Project: Onslow Memorial Hospital - MOB Tenant Improvement  
Jacksonville, NC

Addendum No. 3:

Date: January 8, 2026

RFI Responses

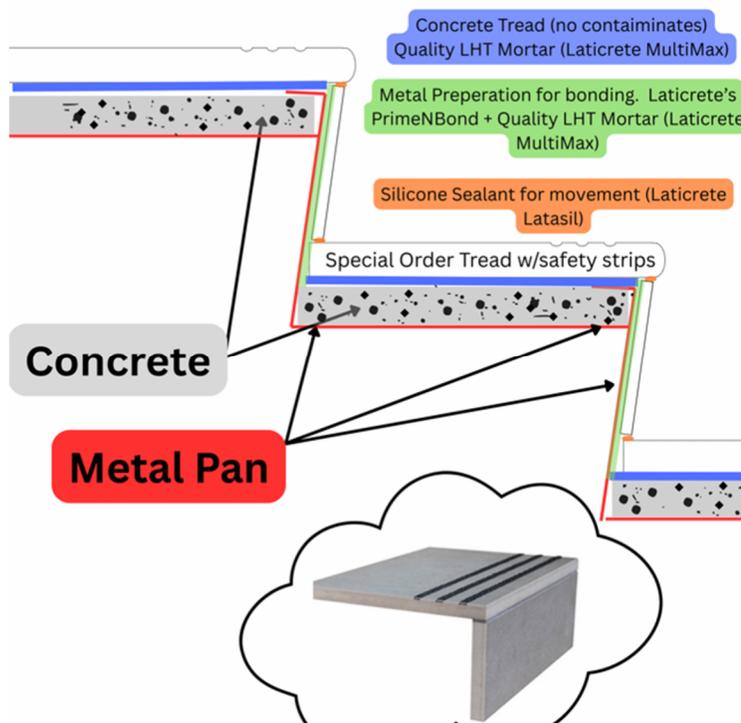
91. Please give some further guidance on the stairwell that is to receive ceramic tile. This is a steel fabricated step with concrete filled treads with an angle front steel nose that are usually slightly radiused on the front leading edge. Are you looking for both treads and risers to be tiled or treads only? Intermediate landing? What do you anticipate the nosing material or profile to be or look like for all nosing areas that are receiving ceramic? Will 2<sup>nd</sup> floor LVP flooring have a vinyl stair nosing where it meets the stairwell?

RESPONSE: Vinyl nosing at 2<sup>nd</sup> floor LVP flooring. Tread Spec is "Special Order" with the Safety strips. Tile centered on the tread and cuts on the edge. Align the riser and tile at the landing with the tread. Preparation of the metal for the riser: epoxy mortar, or bonding primer applicable for this application, example Laticrete PrimeNBond or Mapei's EcoPrim Grip. See detail.
